APPROVED MEETING MINUTES

South Park Plaza

This was the Seattle Design Commission's (SDC) second review of the South Park Plaza project. The purpose of this meeting was to review the schematic design phase (60% design phase) for the project. At this meeting, the SDC voted 9-0 to approve the schematic design for the South Park Plaza project with several recommendations. The SDC will review the project again during the design development phase (90% design phase).

Figure 2: Updated design proposal

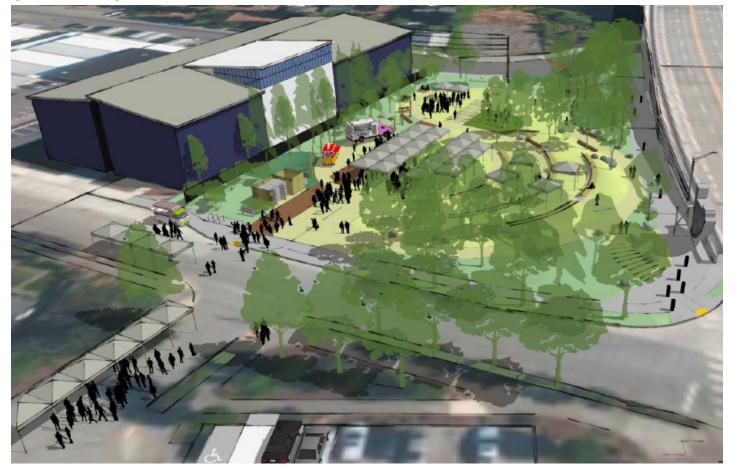
The Commission agreed that the updated proposal provided a balance of larger and small spaces and encouraged the project team to continue to think of how they can best develop these areas to support gatherings. Specifically, Commissioners recommended the project team continue to develop the entry plaza to maximize ability to provide space for large events and community gatherings as well as ensuring that the open lawn and surrounding pathways and spaces are constructed to be able to support large programming.

Commissioners appreciated specific design updates such as the relocation of the play area and the development of an overlook area near the intersection of 14th Ave S and Dallas Ave S. The Commission then encouraged the project team to coordinate with the adjacent property owner on ways to potentially integrate the building façade abutting the plaza, such as by using the façade as a canvas or projection screen for temporary programming or events. Commissioners also recommended the project team continue to understand how the plaza can integrate with other areas outside of the park boundary, such as the King County surplus property, adjacent rain gardens, and right-of-way along S Orr St, as well as the use of Dallas Ave S for larger community events.

The SDC then expressed its appreciation for the openness and accessibility of the updated design proposal and recommended the project team provide a diagram or additional information on the areas and pathways that are accessible to better understand how users of all abilities can enjoy spaces throughout the plaza. Commissioners also encouraged the project team to identify ADA access routes into the plaza from surrounding areas.

- 8. Refine technical detailing of lawn, pathways, and enclosures to ensure they can support large programming
- 9. Provide diagram of accessible pathways and areas within the park
